Planning Inspectorate
Arolygiaeth Gynllunio

SCOPING OPINION:

Proposed Hope Moor Wind Farm

Case Reference: EN0110038

Natural England peat-depth / peat extent mapping (2025)

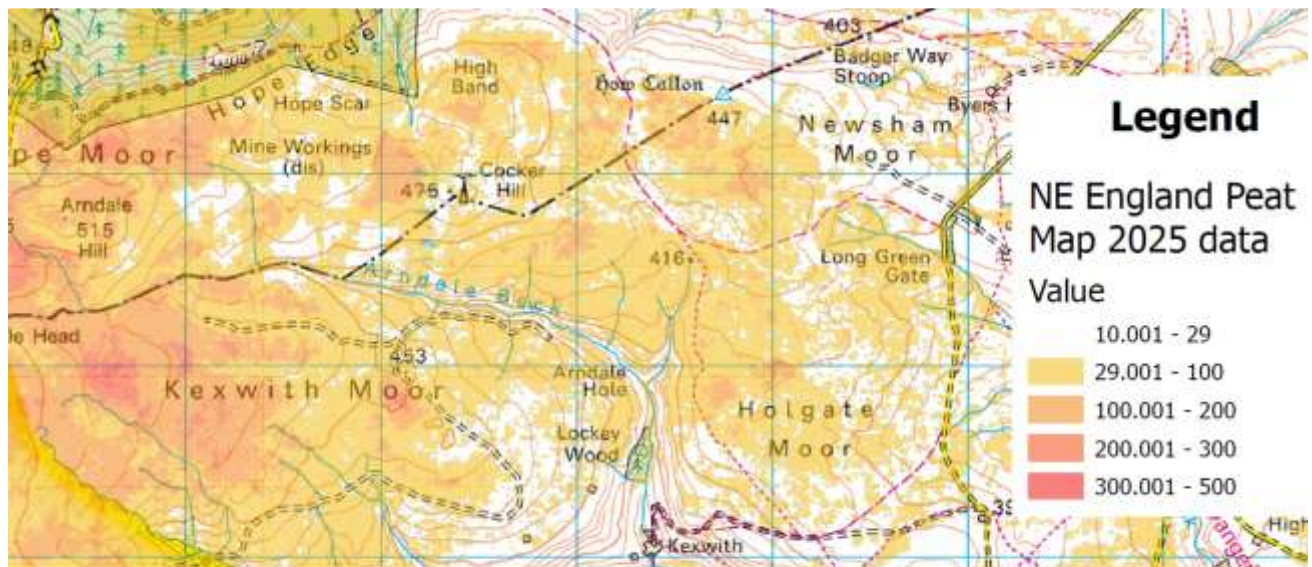
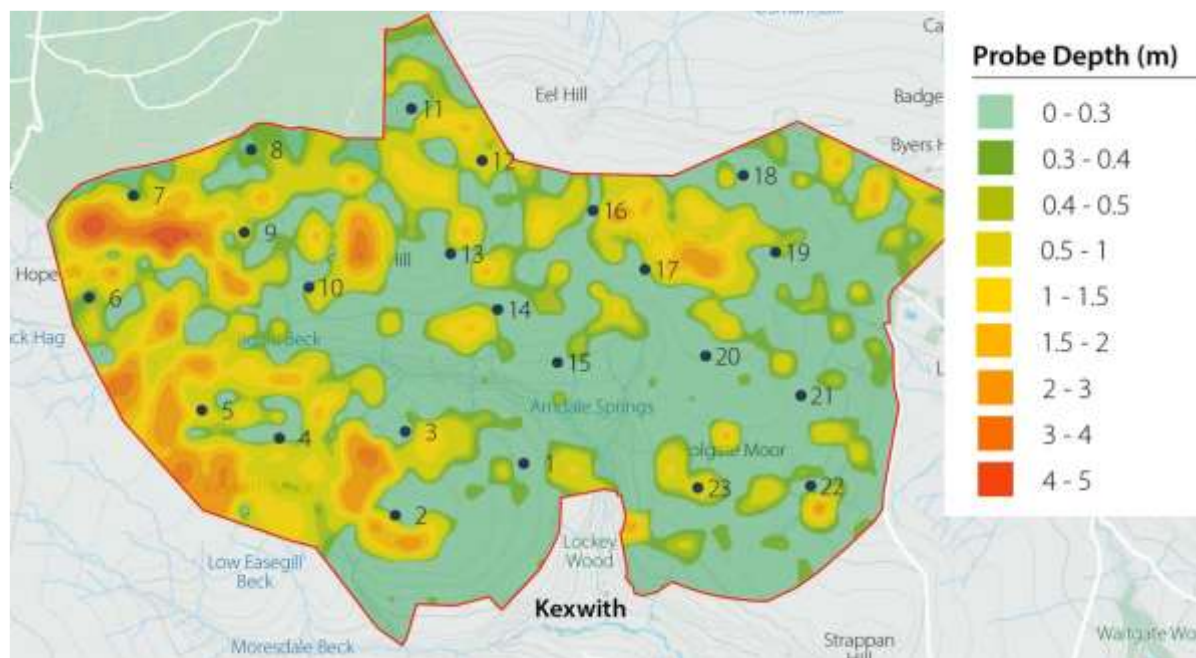
Appendix D – Peat map comparisons

Figure 4.2: Calderdale Cable Search Areas and Access Routes

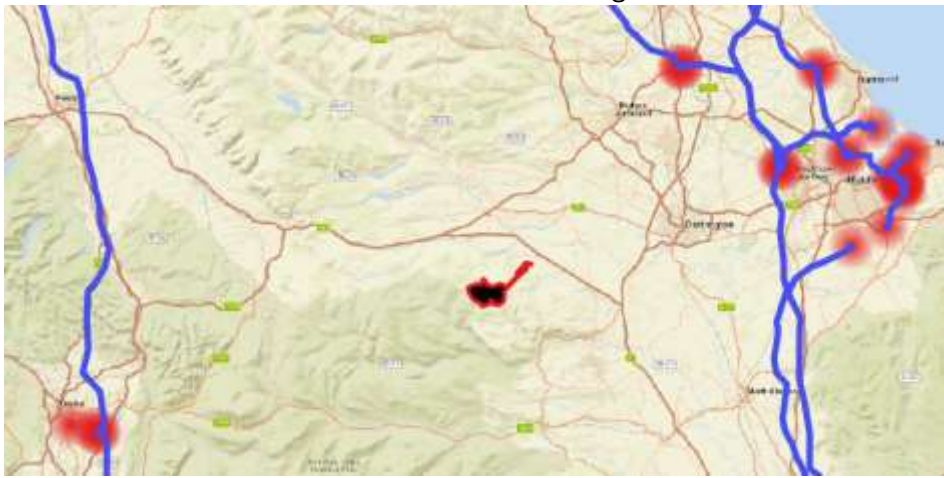
There are many examples of where a grid connection has been planned as part of the same consenting process for the generating facility it serves. The most relevant and recent example is for the 200m wind turbine farm at Calderdale Energy Park (see figure below). This is only other English windfarm DCO application we are aware of.

The EIA Scoping Report for the Calderdale windfarm was deposited with PINS in September 2025 (Reference: EN0110023). The plan includes four options for the grid connection (see their figure 4.2 above). One connection option is in Rochdale, two are in Bradford and one is in Leeds – these points are between 20km and 40km from the wind farm (e.g. see Chapters 4 and 5 in that report). The inclusion of these cable route options is accompanied by plans for in-scope environmental assessments across a range of aspects including ecology/biodiversity,

Diagram not to scale

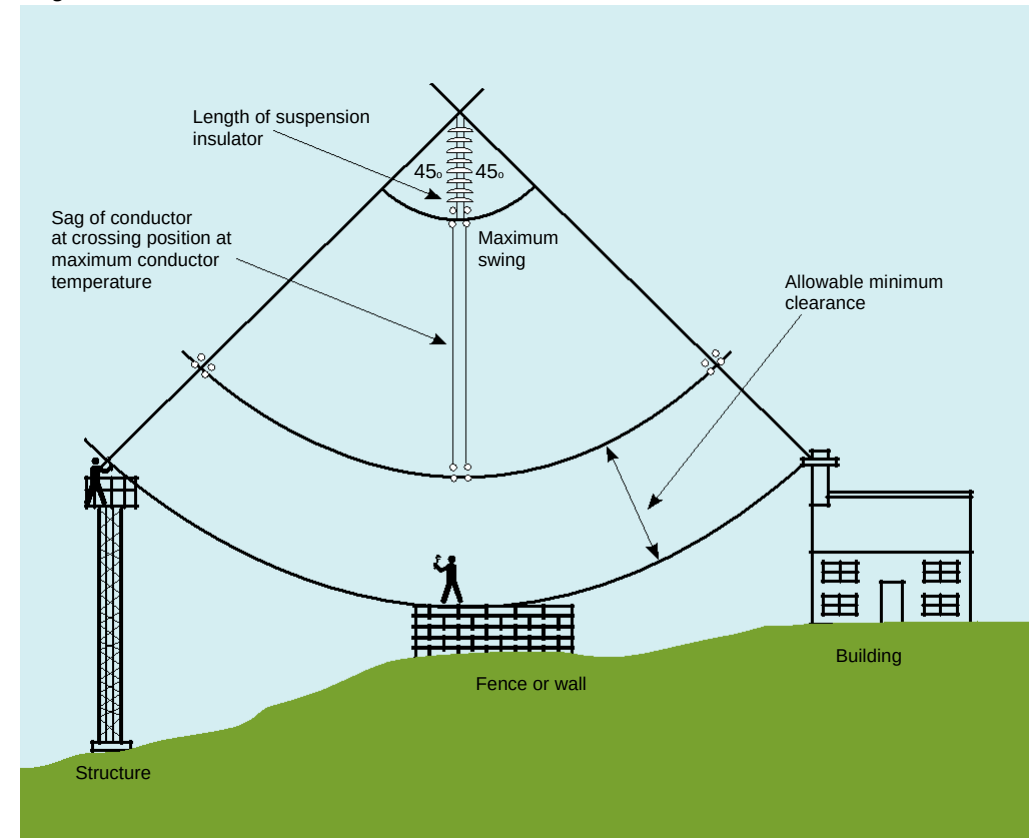
There should be at least 5.3m between the conductors and any structure someone could stand on

Diagram not to scale

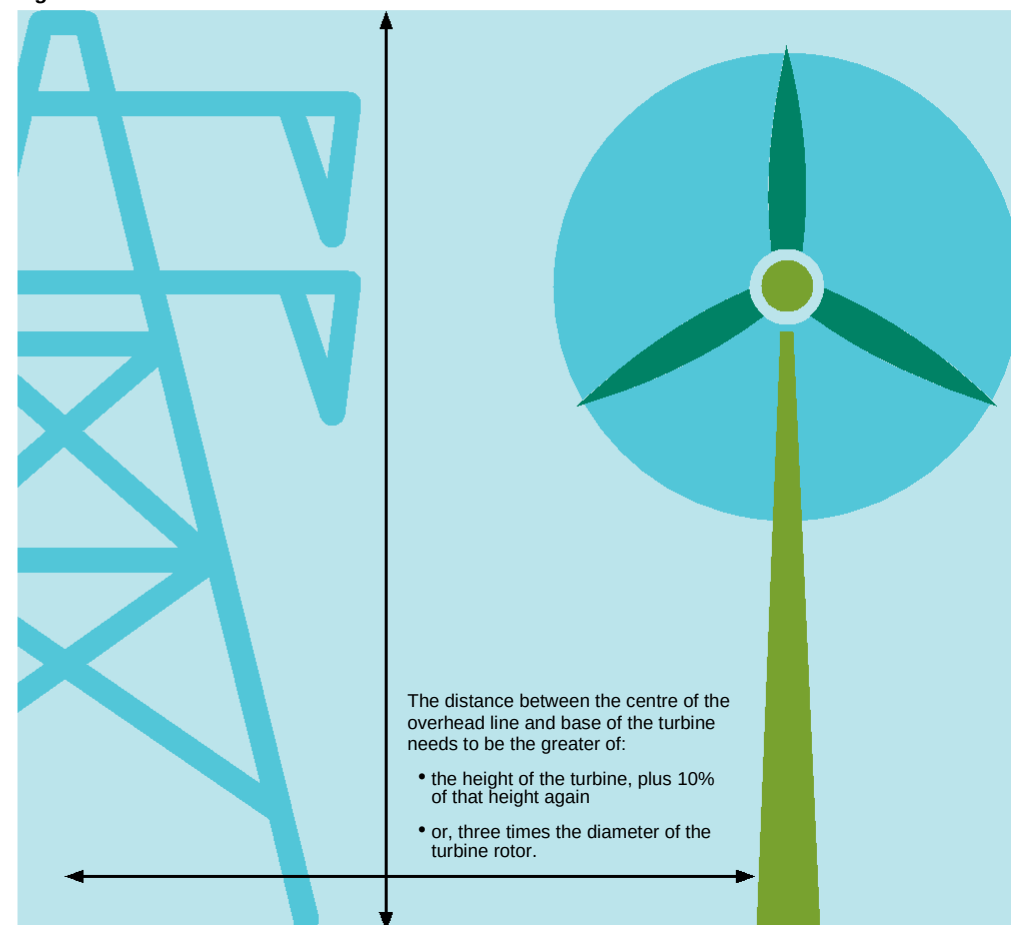
Turbines should be far enough away to avoid the possibility of toppling onto the overhead line

Natural England peat-depth / peat extent mapping (2025)

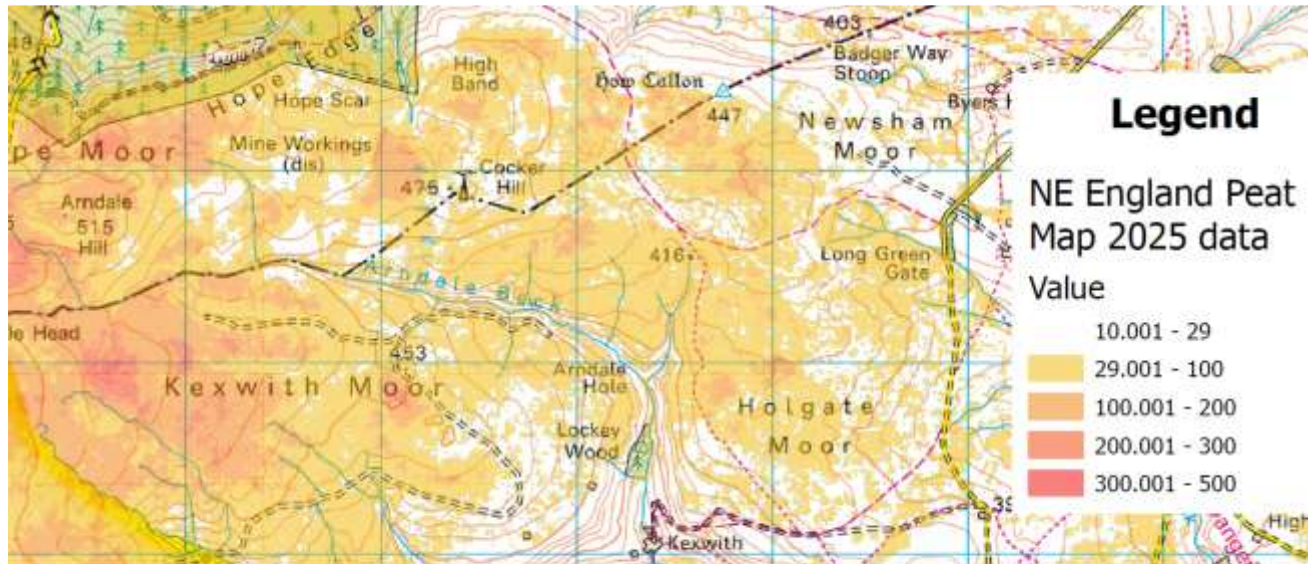
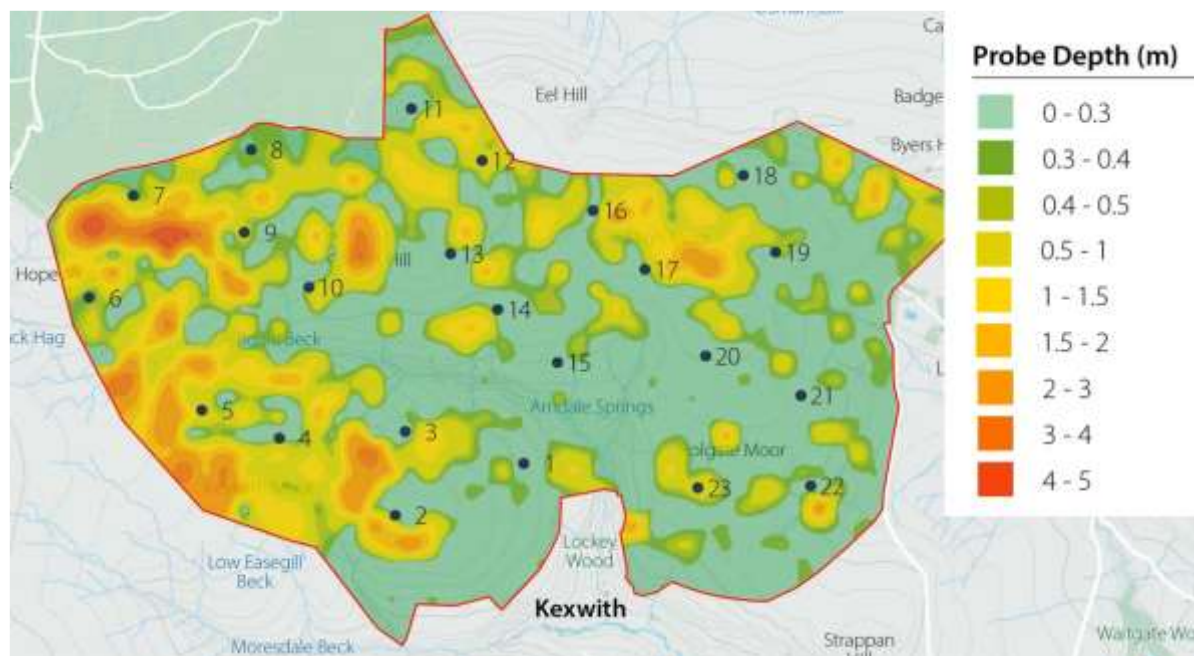
Appendix D – Peat map comparisons
